ADDENDUM NO. 1

To: ALL PROPOSAL HOLDERS
FINANCIAL ITEM NUMBER: 42212217248
CONTRACT NUMBER: E3P67
DESCRIPTION: The improvements under this District Contract consist of SR 77 Landscaping Renovation & Maintenance in Washington County

FOR: State Road 77 Landscaping Renovation & Maintenance in Washington County
Financial Project No. 422122-1-72-48
Contract No.: E3P67

Page No. 31 of the specifications package is revised as follows:

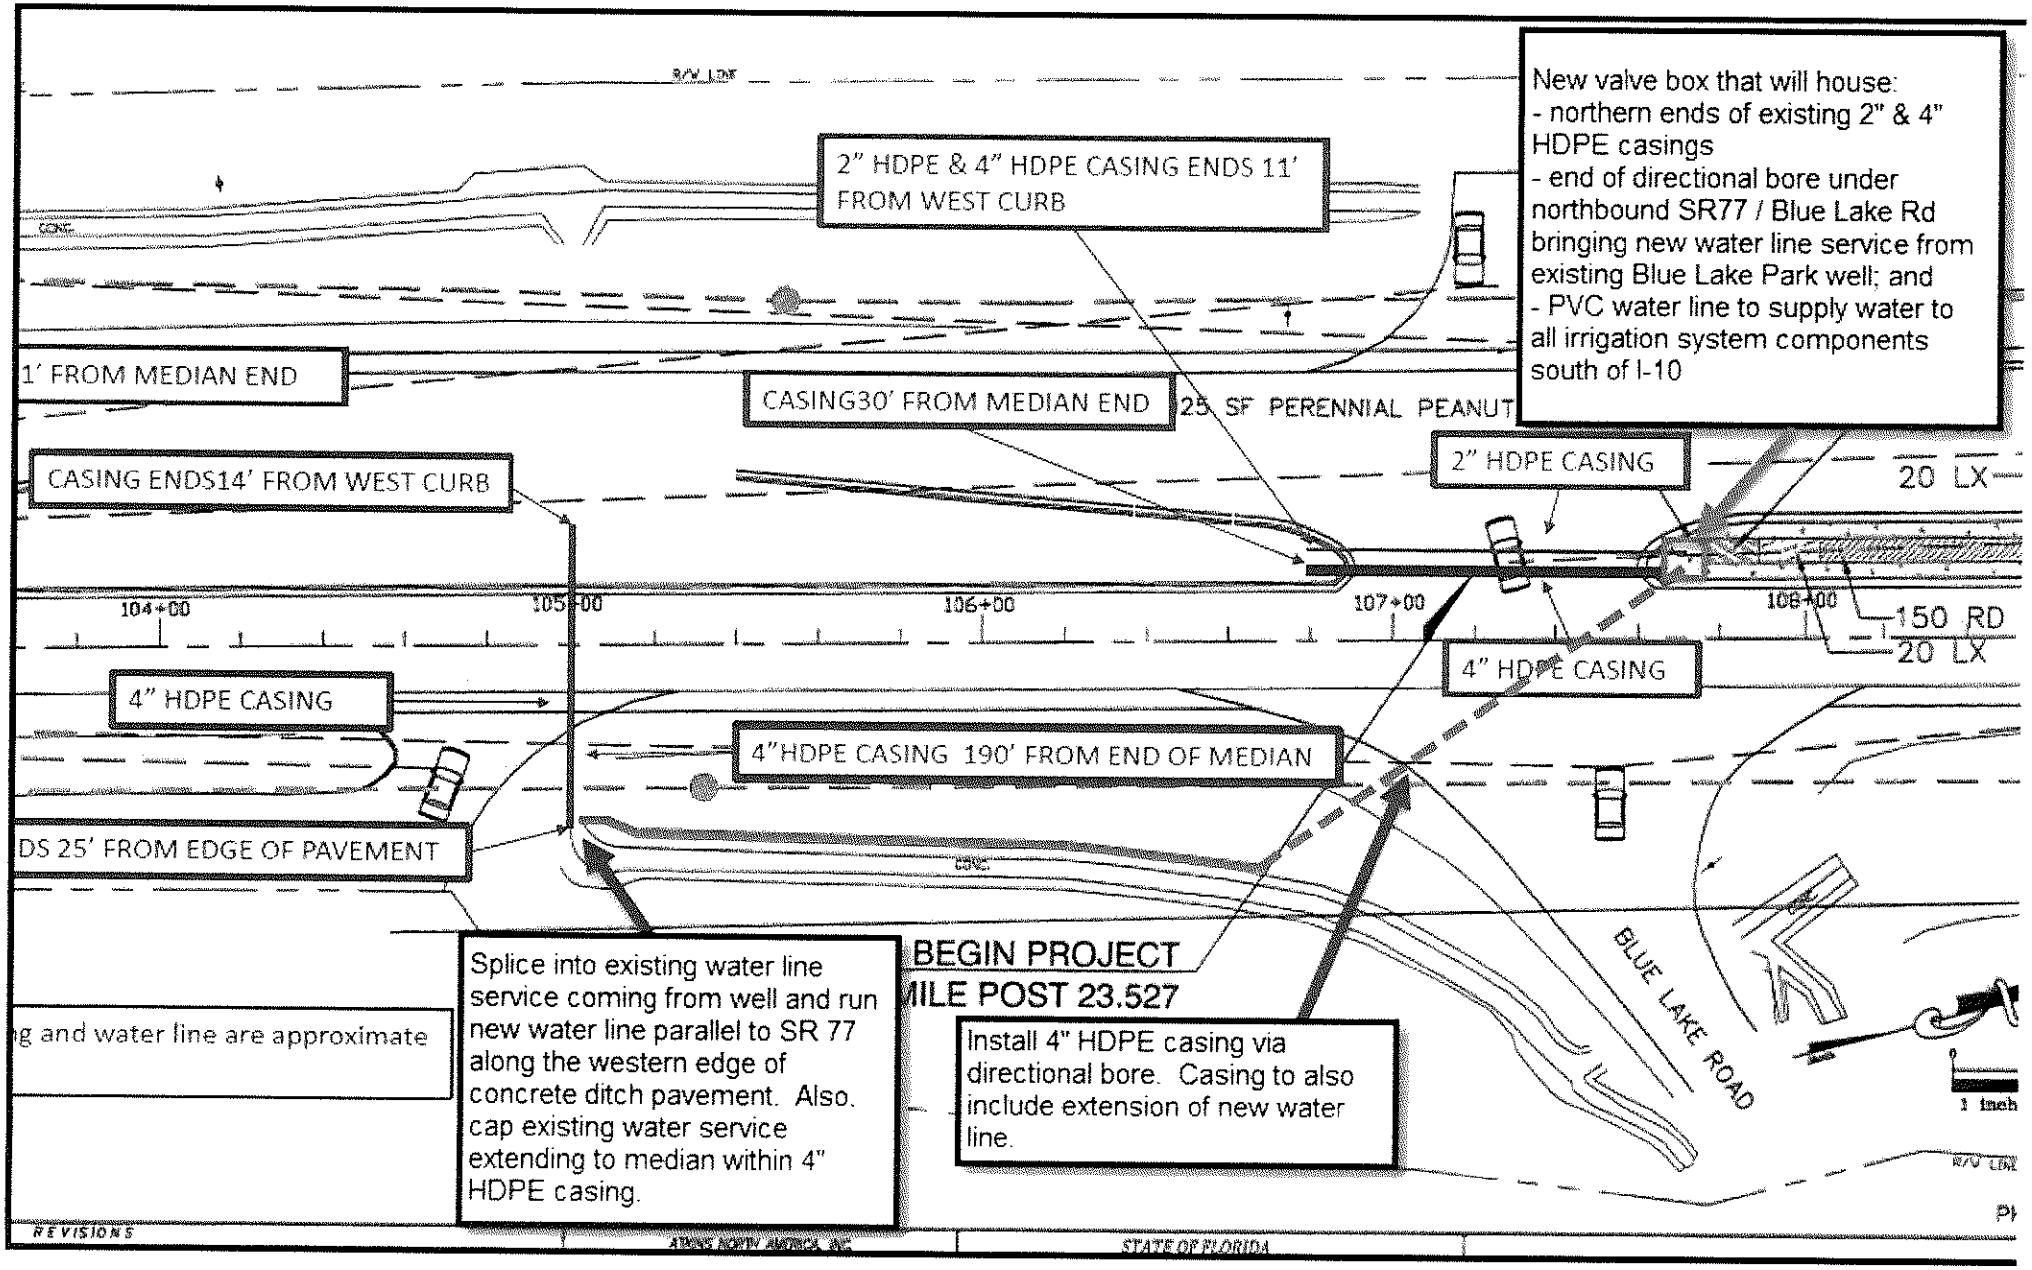
Insert the following paragraph after the 2nd paragraph of Subarticle **580-3.8 Irrigation**:

The existing irrigation system along State Road 77 is presently fed by two different sources. The portion south of Interstate 10 is supported by a well located within the adjacent Blue Lake Park that also services the park bathrooms, while the northern segment of the irrigation system is fed by the City of Chipley municipal water supply. A design-build contract (FP ID: 217909-8-52-01, State Road 77 from south of Clayton Road to north of Blue Lake Road) is presently underway and has the potential to affect the southern portion of the irrigation system due to subsoil excavation that will be performed to a point just south of Blue Lake Road. More specifically, future subsoil excavation has a high likelihood of impacting the existing 4-inch HDPE casing that runs transverse to State Road 77 and supplies water from the park well to the median (approximate STA 105+00 on the supplied informational irrigation plan sheets). In order to avoid conflicts between this landscaping contract and the adjacent design-build project it will be necessary for the landscape contractor to reroute the water supply line for the southern portion of the irrigation system. Splice into the existing water line service from the park well and install a new irrigation line along the east side of State Road 77 that is placed as close as possible to the western edge of the existing concrete ditch pavement. As part of the work associated with splicing into the existing well service also cap the water line extending into the median (approximate STA 105+00 on the supplied informational irrigation plan sheets). At a point south of Blue Lake Road extend the new water line service via directional bore to the southern tip of the first median where landscape work begins (approximate STA 107+80 on the supplied informational irrigation plan sheets). This directional bore shall install a 4-inch HDPE casing under northbound State Road 77/Blue Lake Road. All water lines and any necessary casings shall be installed to a minimum depth of 36 inches. In order to provide for future connectivity to the 2 southern medians excluded from this contract without disturbance to new landscaping installed as part of this work install a valve box near STA 107+80 of sufficient size to house the following items: northern ends of the existing 2-inch and 4-inch HDPE casings that run parallel to State

Road 77; the end of the new casing/water line under northbound State Road 77/Blue Lake Road (installed via directional bore); a valve; and a water line extending northward into the median to supply water to the irrigation system components located south of Interstate 10. A graphical representation of the required new water line alignment is also supplied, and adjustments to the general alignment detailed herein will be permitted with approval of the Engineer. All work shall be performed within the existing right-of-way.

New valve box that will house:
- northern ends of existing 2" & 4" HDPE casings
- end of directional bore under northbound SR77 / Blue Lake Rd bringing new water line service from existing Blue Lake Park well; and

- PVC water line to supply water to all irrigation system components south of I-10
2" HDPE & 4" HDPE CASING ENDS 11' FROM WEST CURB
1' FROM MEDIAN END
CASING30' FROM MEDIAN END
25 SF PERENNIAL PEANUT
2" HDPE CASING
CASING ENDS14' FROM WEST CURB
20 LX
104+00
105+00
106+00
107+00
108+00
150 RD
20 LX
4" HDPE CASING
4" HDPE CASING
4"HDPE CASING 190' FROM END OF MEDIAN
DS 25' FROM EDGE OF PAVEMENT
BEGIN PROJECT
MILE POST 23.527
g and water line are approximate
Splice into existing water line service coming from well and run new water line parallel to SR 77 along the western edge of concrete ditch pavement. Also, cap existing water service extending to median within 4" HDPE casing.
Install 4" HDPE casing via directional bore. Casing to also include extension of new water line.
BLUE LAKE ROAD
1 inch
REVISIONS
STATE OF FLORIDA
